J. Bernie Beasley, Jr., P.E.  
Vice President  
Vogtle Project

**VOGTLE ELECTRIC GENERATING PLANT  
REQUEST TO REVISE TECHNICAL SPECIFICATIONS  
REACTOR TRIP SYSTEM INSTRUMENTATION OVER TEMPERATURE DELTA  
TEMPERATURE (OTDT) REACTOR TRIP FUNCTION**

**MARKED-UP TECHNICAL SPECIFICATION AND BASES PAGES**

Table 3.3.1-1 (page 7 of 8)  
Reactor Trip System Instrumentation

Note 1: Overtemperature Delta-T

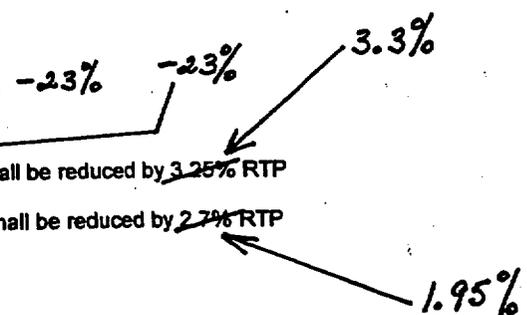
1. for AFD between ~~-32%~~ and +10%, = 0% RTP
2. for each % AFD is below ~~-32%~~, the trip setpoint shall be reduced by ~~3.25%~~ RTP
3. for each % AFD is above +10%, the trip setpoint shall be reduced by ~~2.7%~~ RTP

Insert 1 →

**Insert 1**

(o) The compensated temperature difference  $\frac{\{1 + \tau_4 s\}}{\{1 + \tau_5 s\}} \left[ T \frac{1}{\{1 + \tau_6 s\}} - T' \right]$  shall be no more negative than 3 degrees F.
